Amendments to the Drawings:

REMARKS

Appl. No. 10/510,525
Response dated November 11, 2005
Response to Office action of August 11, 2005

Fig 1 (Prior Art)

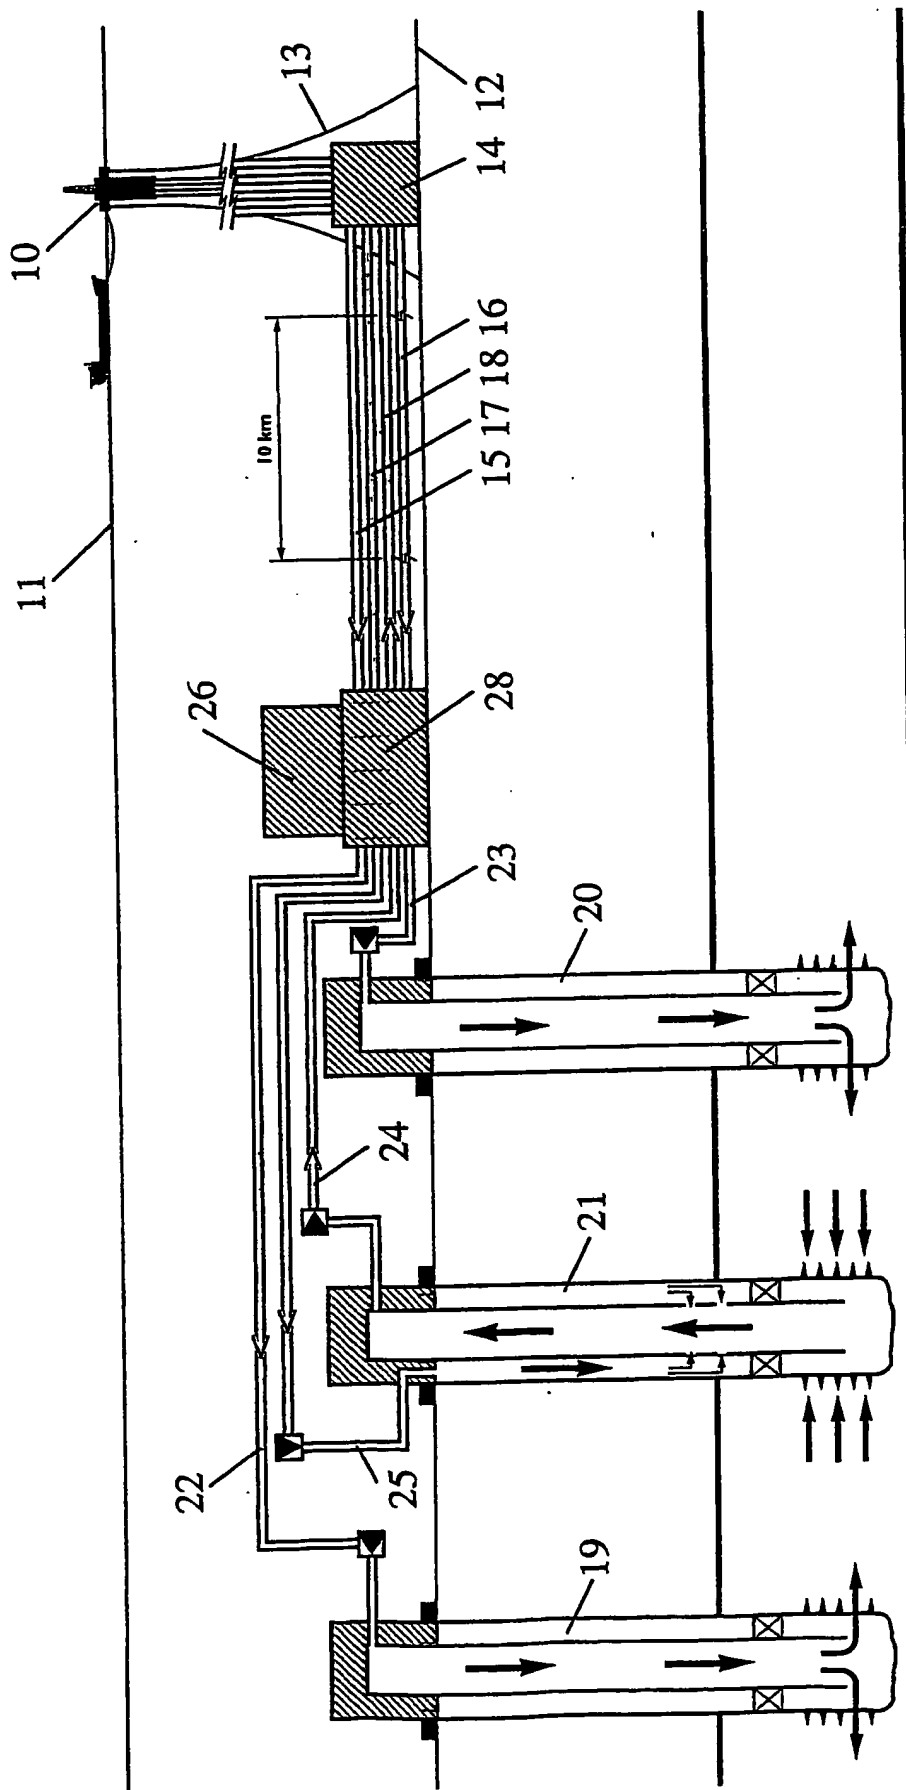
The attached annotated sheets of drawings include changes to Figures 1, 2, and 11. These sheets, which include Figures 1, 2, and 11, show the changes to the original sheets including Figures 1, 2, and 11. In Figures 1, and 2, the text "(Prior Art)" has been added. In Figure 11, reference characters 156, 157, 158, and 159 have been removed.

In amended Figures 1 and 2, the text "(Prior Art)" has been added. In amended Figure 11, the element numerals 156, 157, 158, and 159 have been removed.
